**Mansfield Planning Scheme Amendment C48mans
Mansfield Township Approaches**

Panel Report

21 April 2022

Figure 6 Post exhibition proposed change from DDO1 to DDO2

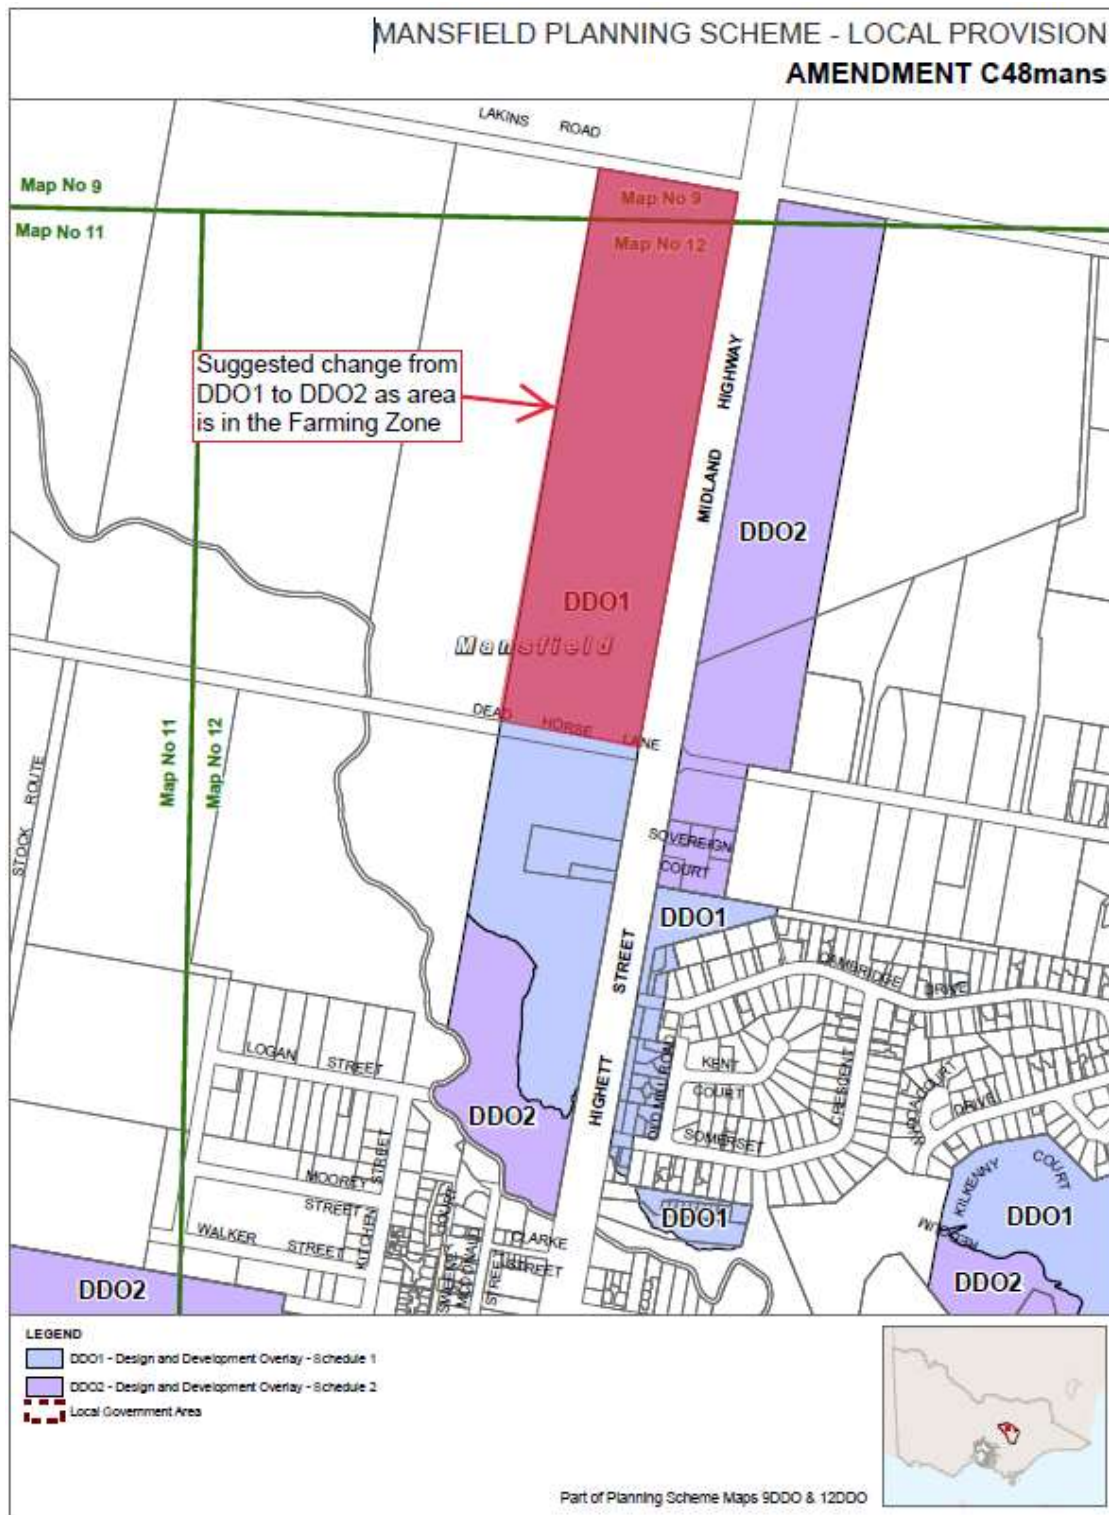
- the large area of land on the west of the Midland Highway, north of Dead Horse Lane (see Figure 6) proposed to change from DDO1 to DDO2 as the land is in the FZ
- the area of land on the south side of the Maroondah Highway at the eastern most end of the township approach (see Figure 7) proposed to change from DDO2 to DDO1 as the land is in the RLZ.
